annual report to the nasa administrator by the aerospace safety advisory panel on the space shuttle program

part I — observations and conclusions

june 1976

FIGURE 1 - Altitude versus Range (Typical trajectory)

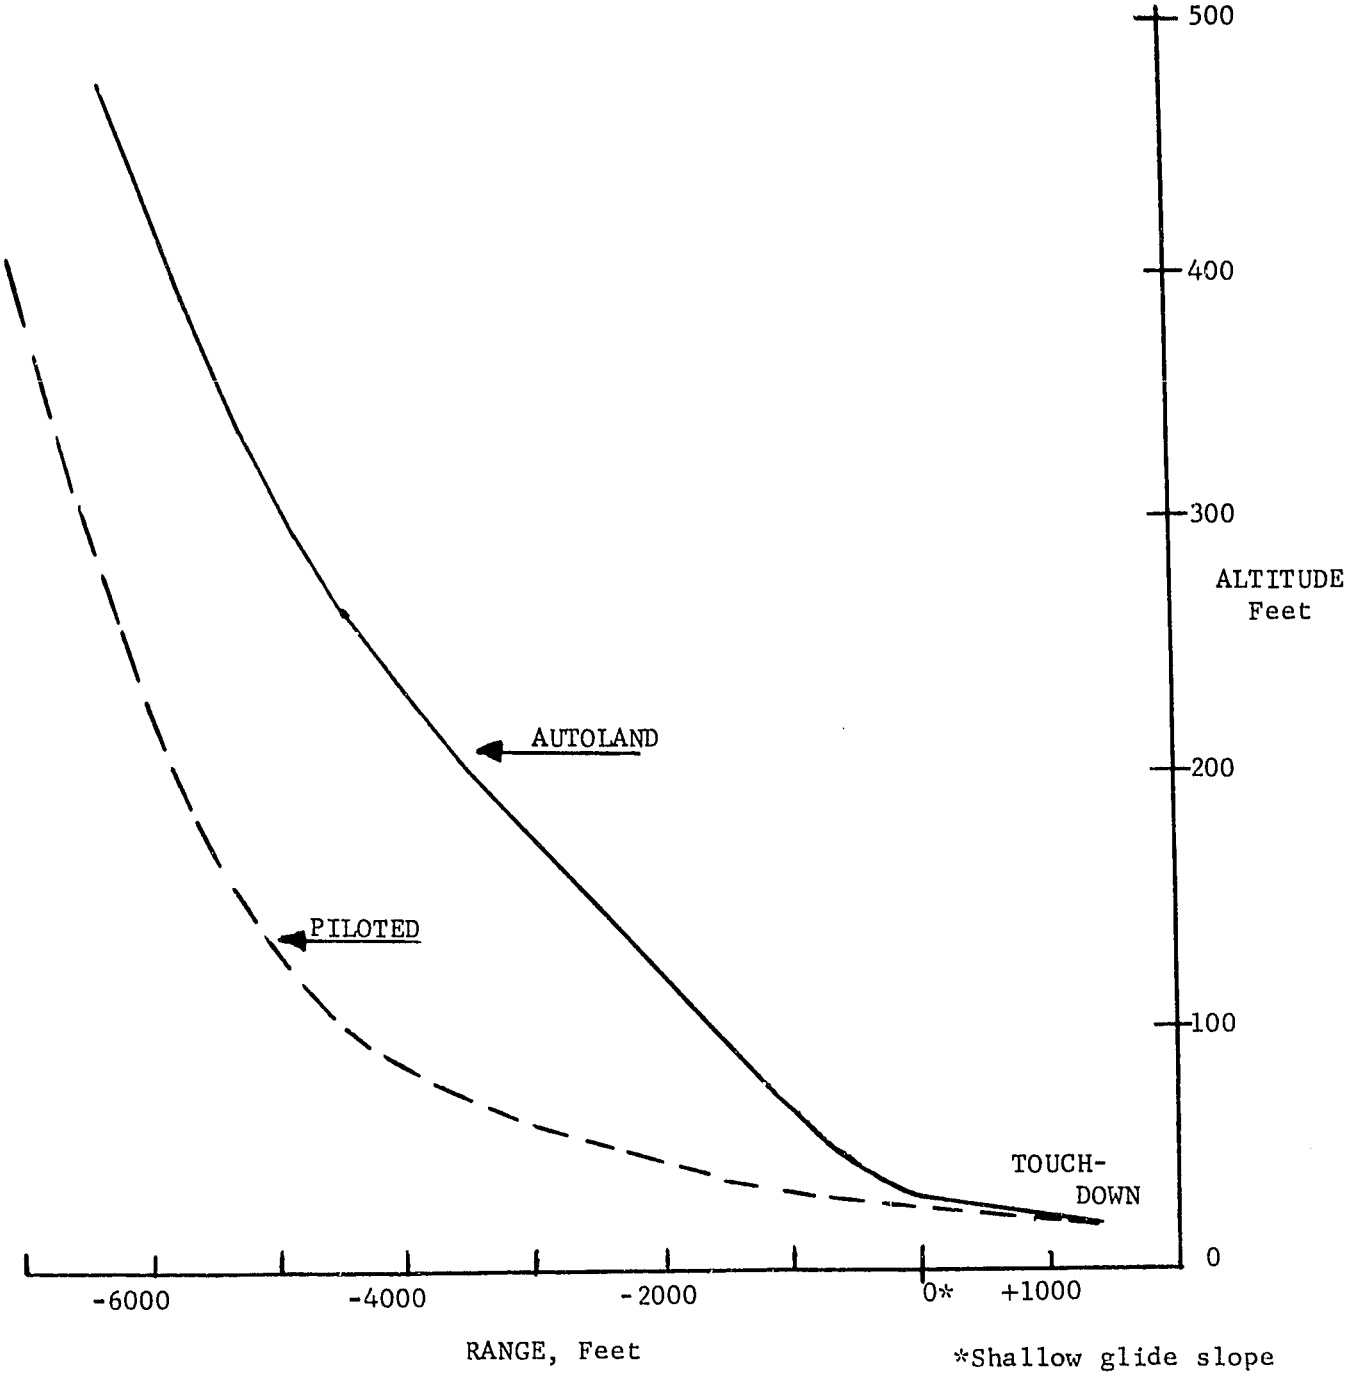
E. The profile or energy management for approach, flare and landing are different for autoland and manual control modes. Figure 1 shows this difference. Effort is now underway to make the automatic and manual profiles identical. The Panel believes this to be essential. This will make it possible for the crew to follow the progress of an automatic landing, and, if necessary, accomplish the transition from automatic to manual with a minimum of exposure to error.
